DEPARTMENT OF THE ARMY
CHARLESTON DISTRICT, CORPS OF ENGINEERS
69-A Hagood Avenue
CHARLESTON, SOUTH CAROLINA 29403-5107

Regulatory Division

Re: Interstate 77 Widening and Rehabilitation (from MM 15 – MM 27)
USACE SAC-2015-00155. SCDOT PIN P027002

SECTION B-B'

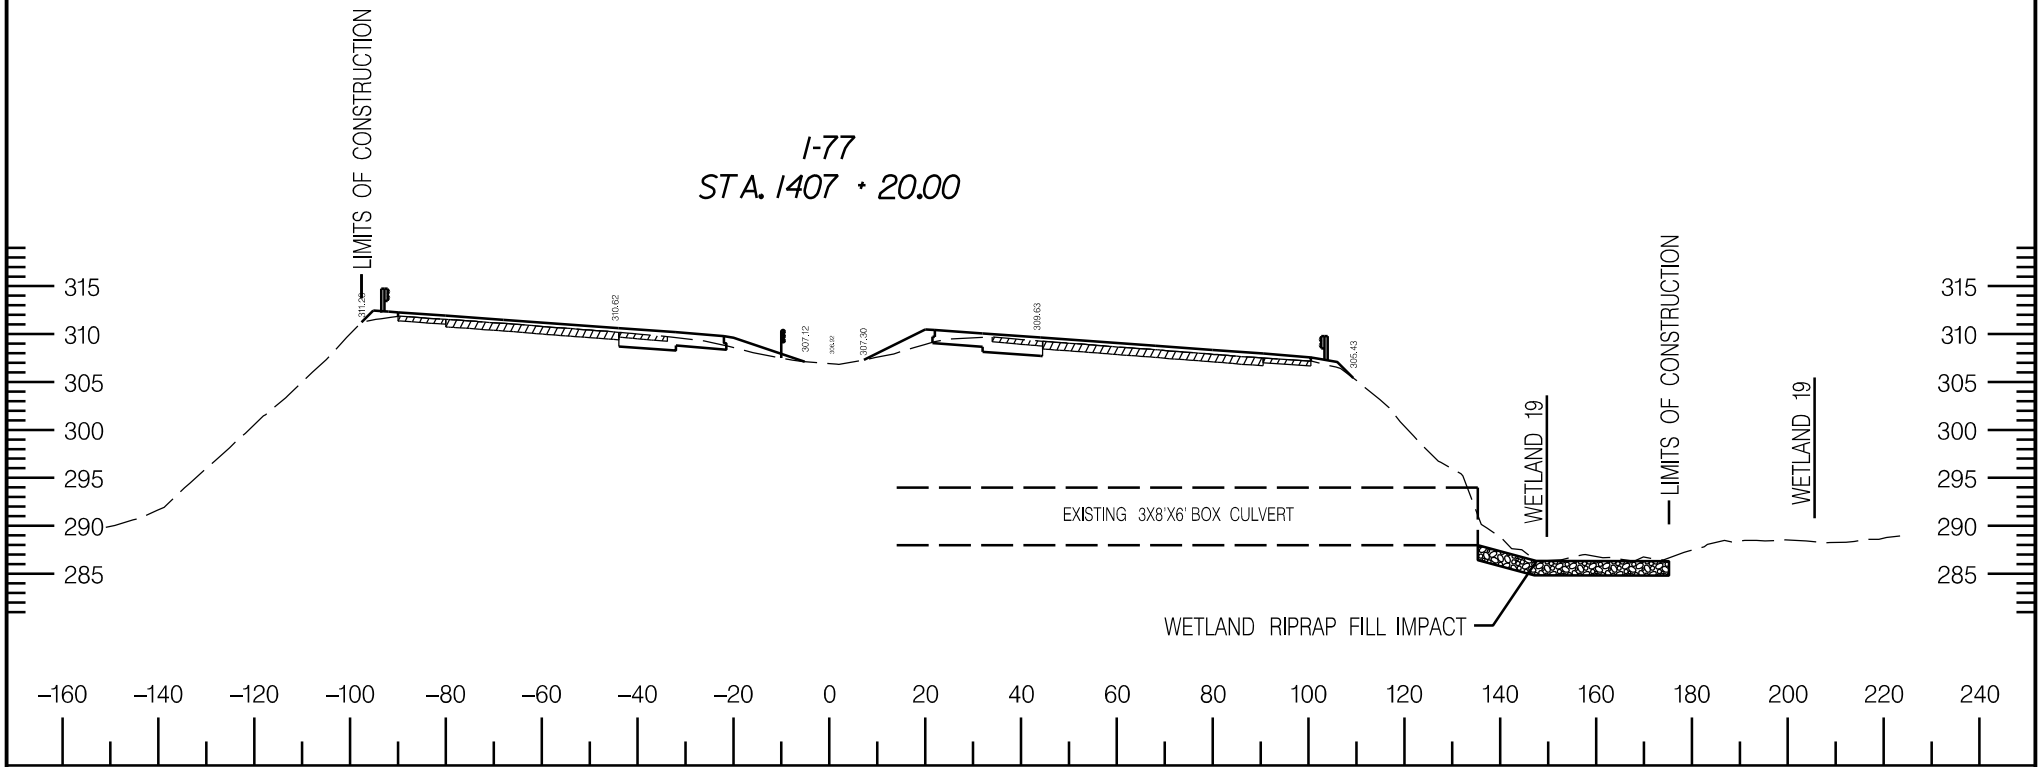
4. In reviewing the submitted drawings, it appears that some cross sections show proposed rip-rap pads above the bottom invert of culverts, specifically cross-section views B, F, J, and K. Please explain. Be advised that to maintain water flow during low flow conditions, all rip-rap stone must be placed so that the top of the stone is flush with existing ground surface. Please revise the detail sheets if necessary.

4. *You noted rip-rap pads above the bottom invert of culverts, specifically sections B, F, J, and K.*

Sections B, F, J, and K have been adjusted and are enclosed as Revised Sheets 17, 21, 25, and 26 (of 31) with a Revision Date of 10/27/16. These adjustments did not result in any impact changes and are incorporated into the construction plans.
